Office Action Summary

10/046,012

Claim 2 is rejected under 35 U.S.C. 102(b) as being anticipated by Morgan (USPN 3050761).

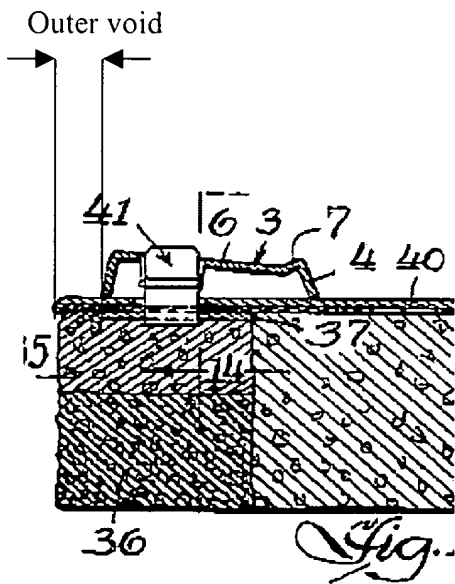
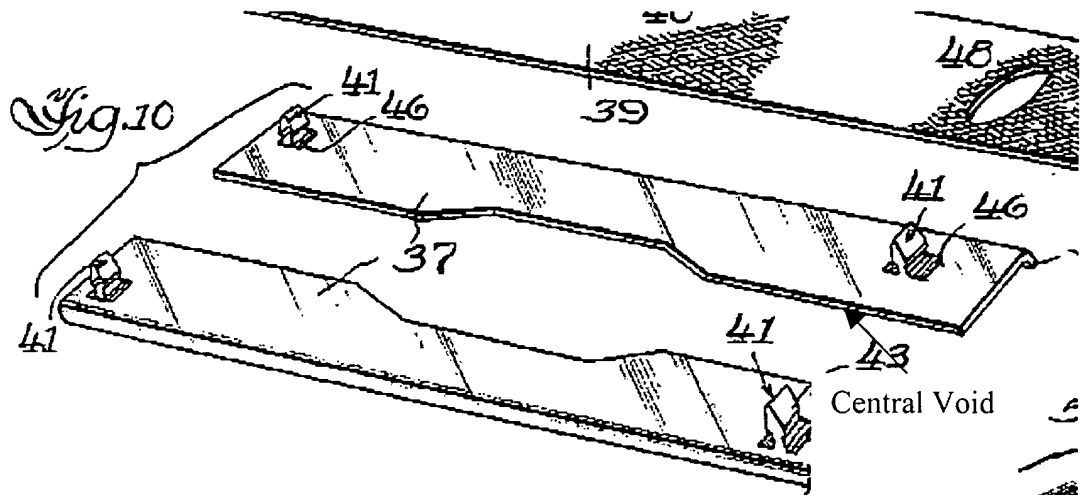
Morgan teaches a latch to secure a mop head to a handle comprising a pair of opposed tabs (41). The upper and lower portions of the tabs correspond to apertures (53) in the mop head. The central portion of the tab ramps (43) outward such that the dimensions between the opposed tab ramps is larger than the aperture opening. The tabs are centrally located on a beam (37) that extends a short distance beyond either end of the tab until attaching to a backing plate (39, 49). There is a central void between the beams and an outer void further defining a space outside each beam (see figures below).

Claim 2 is rejected under 35 U.S.C. 102(b) as being anticipated by Empire Brush Prior Art.

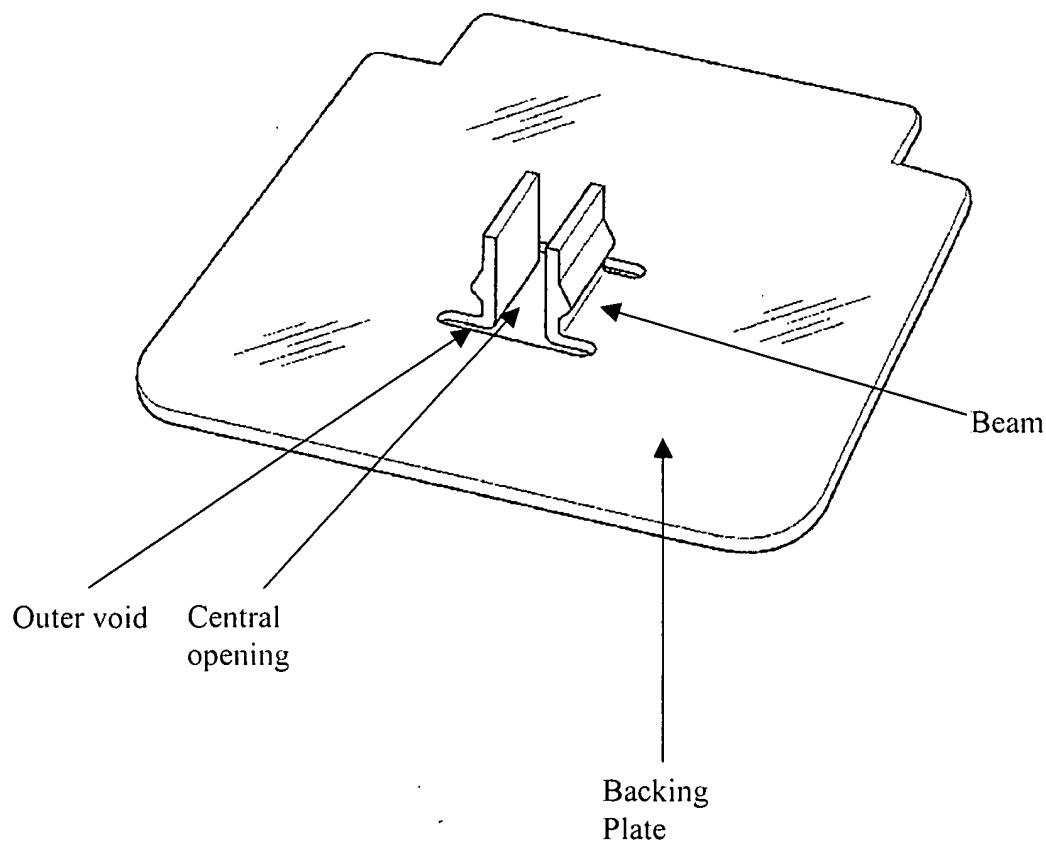
Empire Brush teaches a latch to secure a mop head to a handle comprising a pair of opposed tabs. The upper and lower portions of the tabs correspond to apertures in the mop head. The central portion of the tab ramps outward such that the dimensions between the opposed tab ramps is larger than the aperture opening. The tabs are centrally located on a beam that extends a short distance beyond either end of the tab until it attaches to a backing plate. There is a central void defining a space between the beams and an outer void defining a space outside each beam (see figure below).
